<b>ITS: 6358</b>	
<b>SECTION:</b>	260 Battery Compartment
<b>WRITTEN BY:</b>	Alan Mark
<b>SUBJECT:</b>	Rewire voltage regulator power

# ITS6358

To rewire the voltage regulator power from the battery side to the load side of the battery disconnect switch to prevent equipment from being damaged if a severe load dump occurs.

**Figure 2: Fuse box main battery disconnect switch**

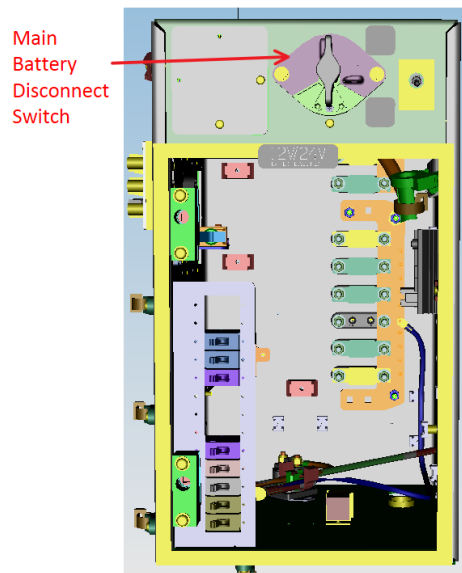
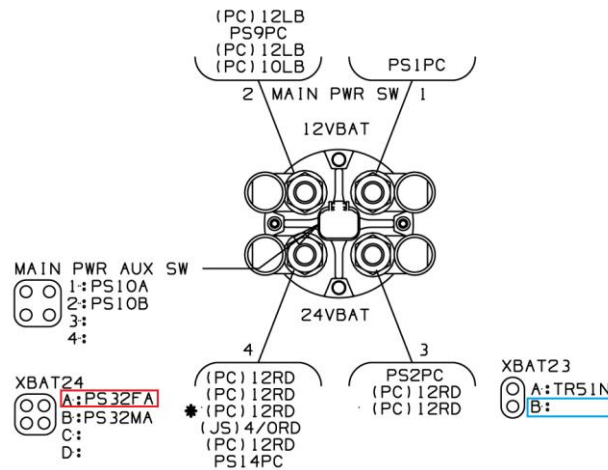
3. Locate the connector XBAT24 on the main battery disconnect switch within the fuse box. Figure 2 shows the location.
4. Remove the wire labeled “PS32FA”.
5. Cut off the existing terminal and re-terminate with the provided socket (PN: 102879).
6. Locate the connector XBAT23 and insert the newly terminated wire into cavity B of the tower. Figure 3 displays the resulting electrical schematic.
7. Remove all tools and debris and return the bus to service condition.
8. Turn the main battery disconnect switch to the “ON” position.
